ADDENDUM #2

TO: ALL PLAN HOLDERS AND POTENTIAL BIDDERS
FROM: RON VENTURELLA, PURCHASING OFFICER *RV*
SUBJECT: SYNTHETIC TURF FIELD REPLACEMENT
ERWIN & OWEN HIGH SCHOOLS
(RFP# 07-16)

Synthetic Turf Field Replacement
CHA Consulting, Inc. – Project No.: 31080

ADDENDUM NUMBER TWO

FIG: SR-100.01

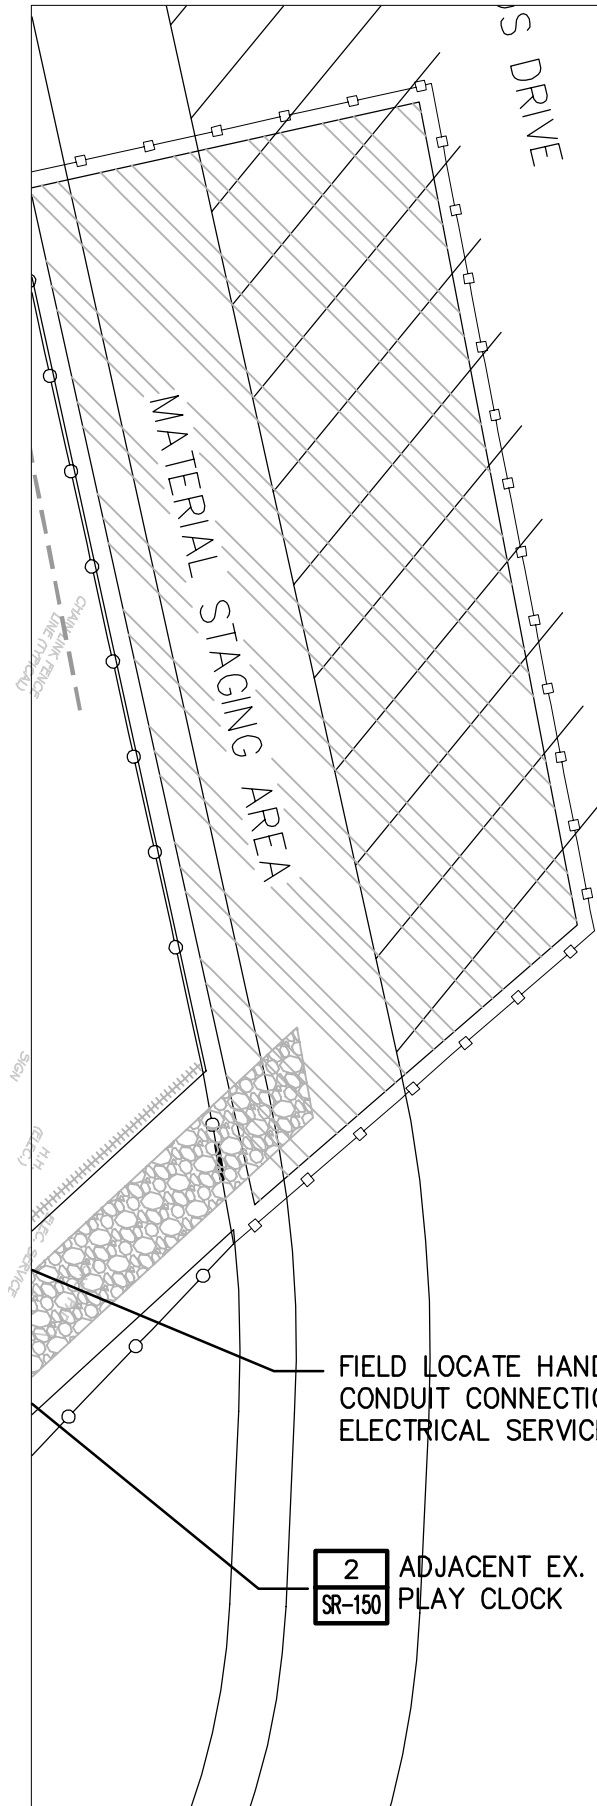
1. Erwin High School; Sheet SR-100: Field Site Plan:
 - A. Revise drawing per figure SR-100.01, as attached herein.
2. Erwin High School; Sheet SR-150: Field Utility Plan:
 - A. Revise drawing per figure SR-150.01, as attached herein.

1
APPROXIMATE LOCATION EX. 8" HDPE
PER RECORD DRAWINGS (DATED
MARCH 12, 2007) – POTHOLE
EXCAVATE FOR PIPE LOCATION,
INSTALL NYLOPLAST INLINE DRAIN
ADAPTER
(TYPICAL – 4 LOCATIONS EACH SIDE)

FIELD VERIFY CROSSBAR
AT 10' ABOVE FG OF
PLAYING SURFACE
2198.08
